Ref. No.: A/SLC/191

Reply to Town Planning Comments (1) on 17/6/2025

Responses to Head of the GEO, CEDD for A/SLC/191

Fig. 1

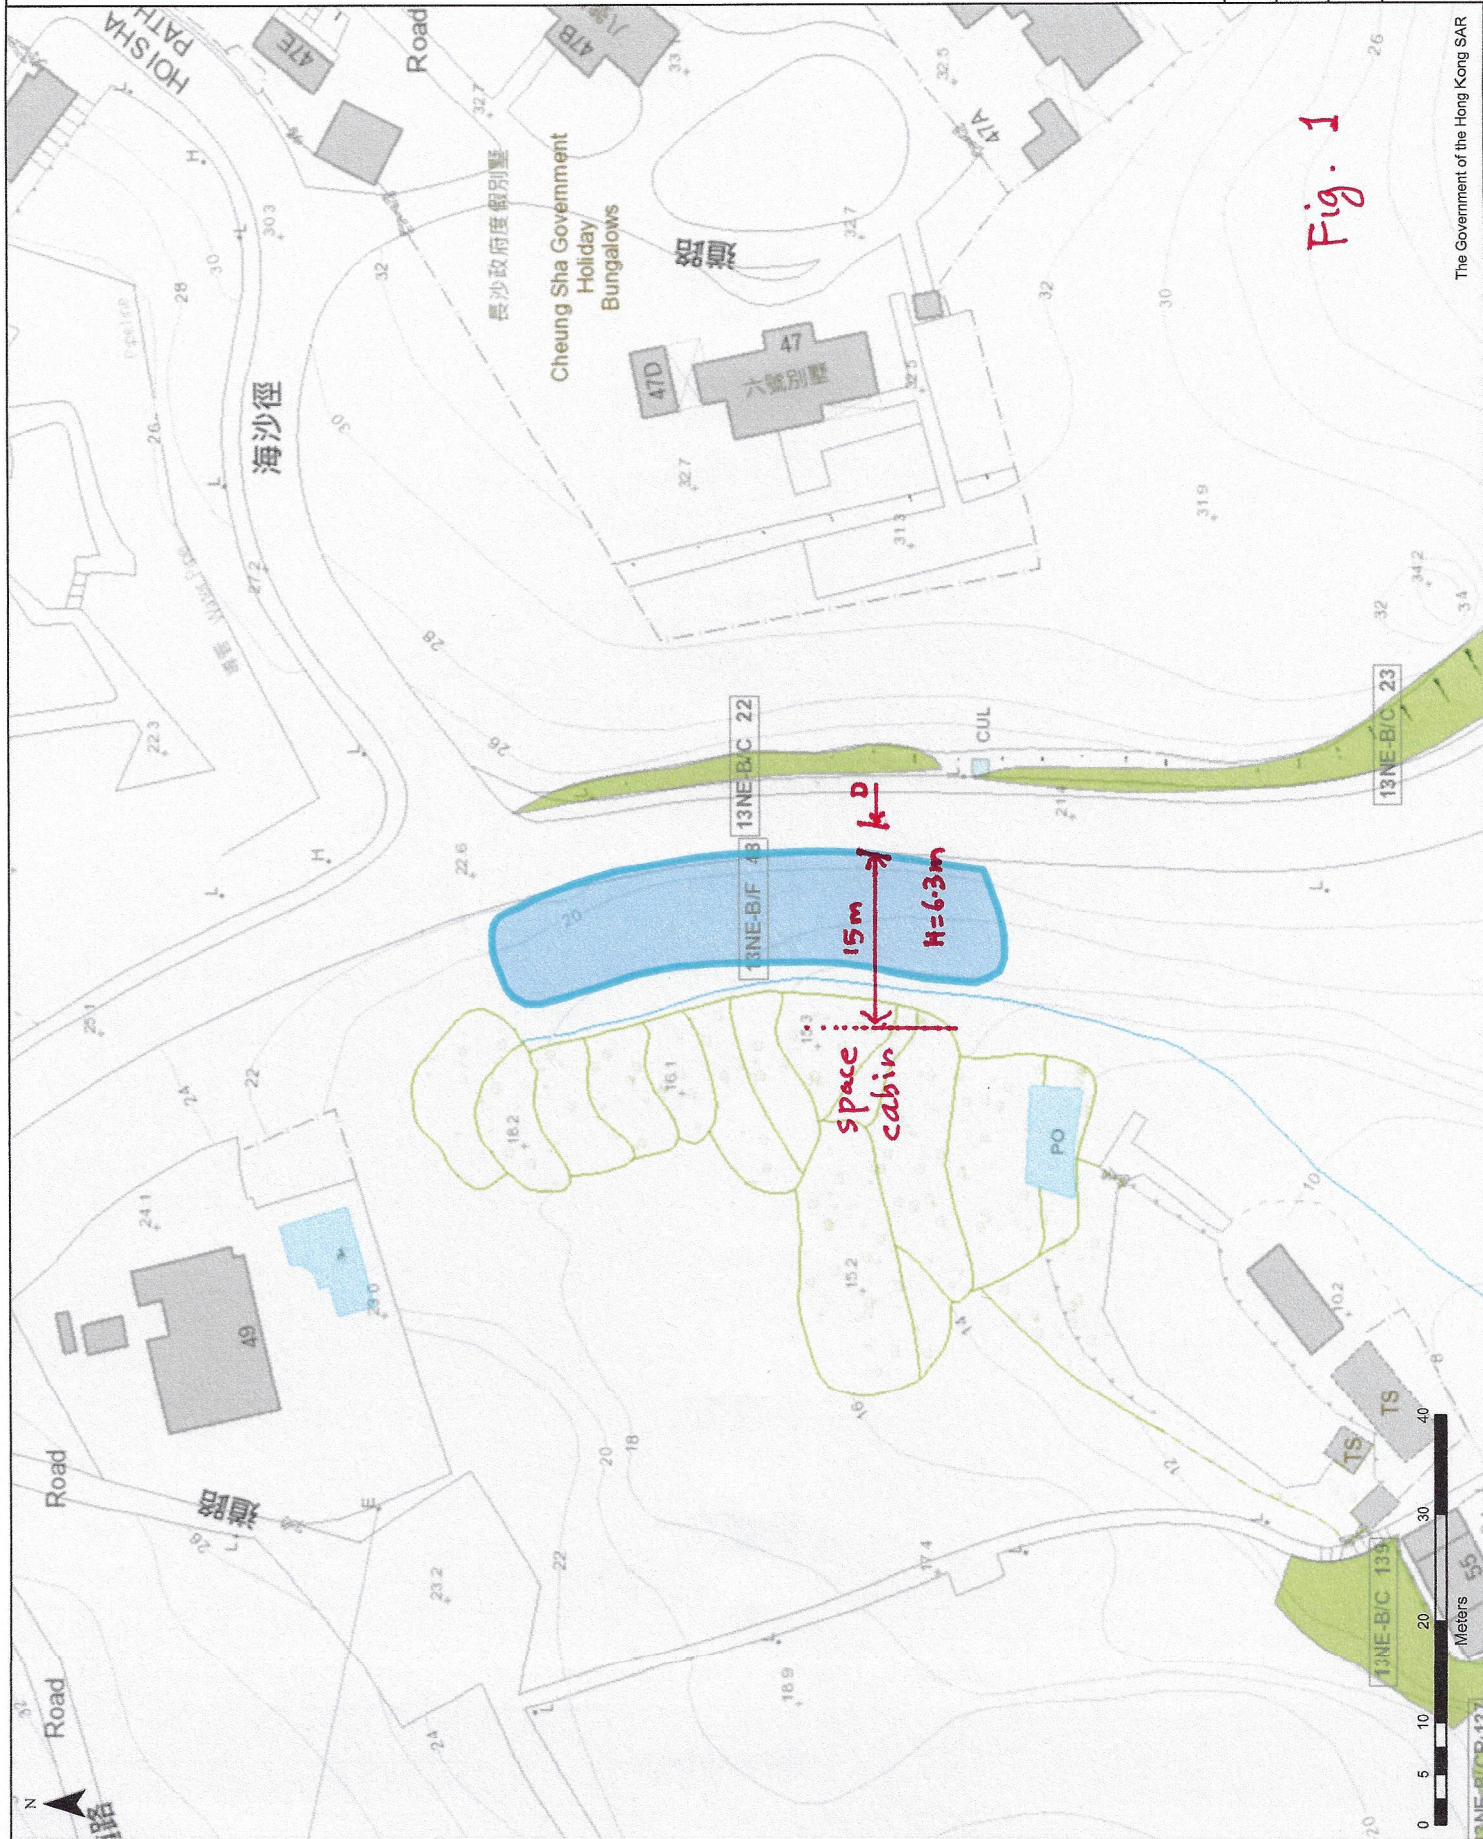
We have carried out a preliminary study on a slope which is situated outside the Application Site namely 13NE-B/F 48.

- a) Slope Information System, Feature No. 13NE-B/F 48 Fig. 1
 - i. Max. Height : 6.3m
 - ii. Length : 50m
 - iii. Average Angle : 35deg.
 - iv. Type of Toe Facility : Lightly-used open area/facility
 - v. Type of Crest Facility : Road/footpath with moderate traffic density

- 1) The crest influence zone $D = 0.4 \times 6.3\text{m} = 2.52\text{m}$
- 2) The horizontal distance from the nearest Space Cabin to slope crest as measured on plan is 15m.
- 3) Crest influence zone + horizontal distance = $2.52 + 15 = 17.52\text{m}$
- 4) Then the travel angle = $\text{arc tan}(6.3/17.52) = 19.8 \text{ deg} < 20\text{deg}$ OK

Figure 1 – Relationship between Travel Angle and Landslide Volume for Selected Slope Failures in Hong Kong

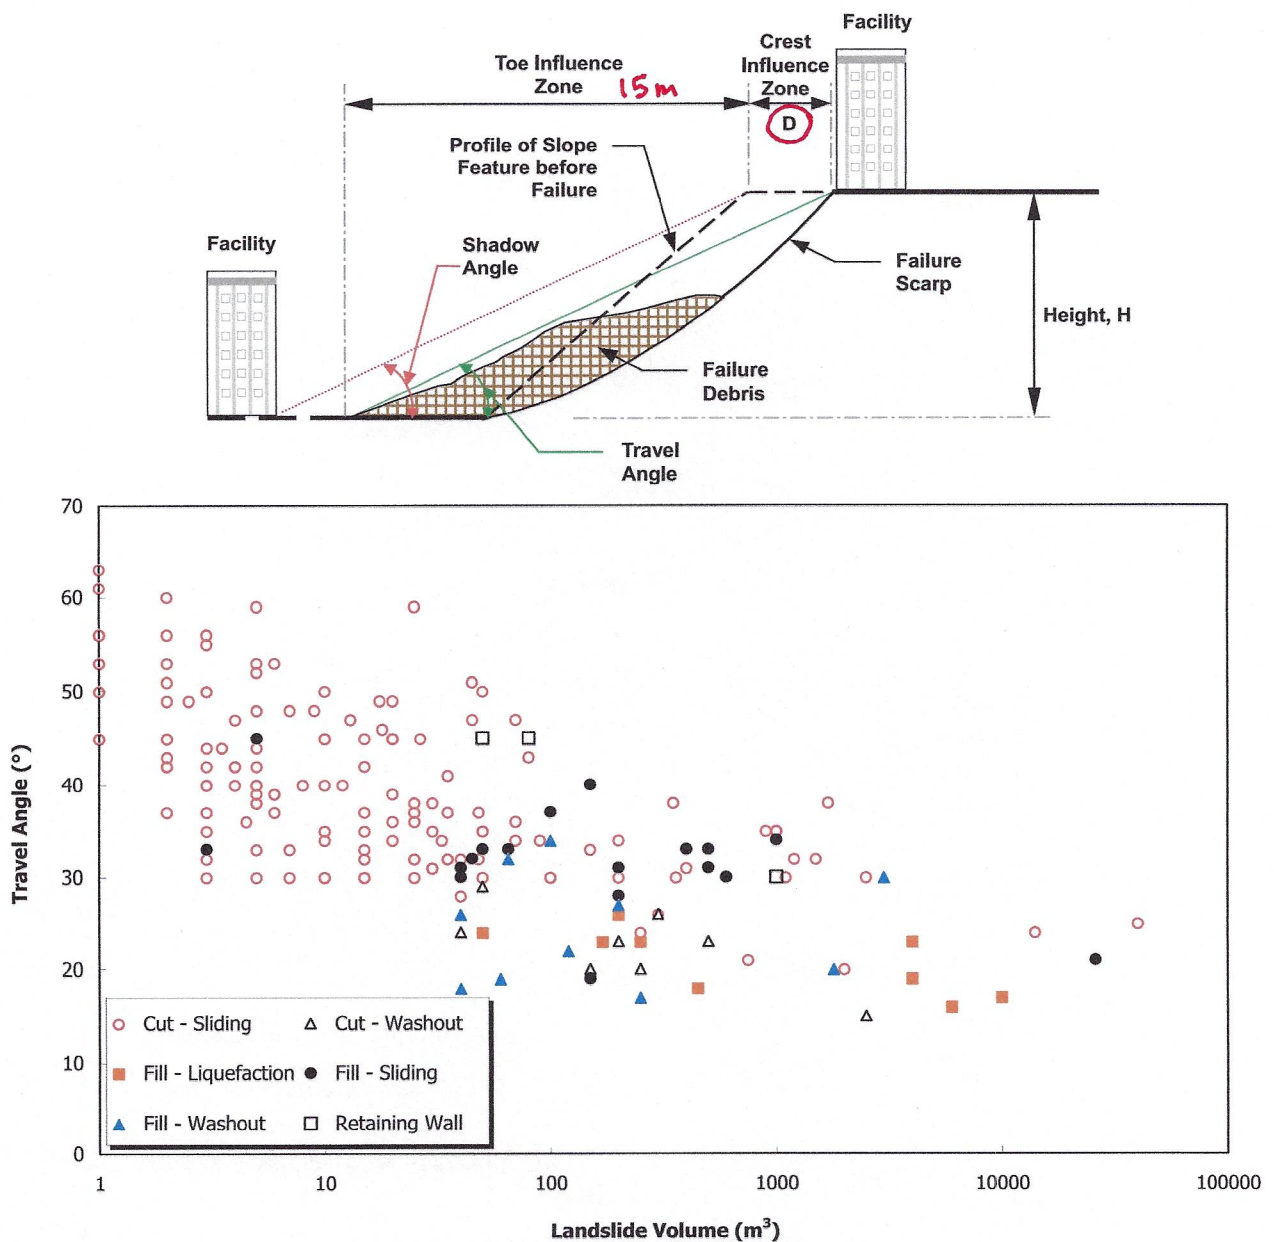
Calculations on the travel Angle as defined in Fig 2 & Fig.3

- a) The existing slope is a fill slope with debris volume less than 300cu.m when failure
- b) The travel angle shall control less than 20deg
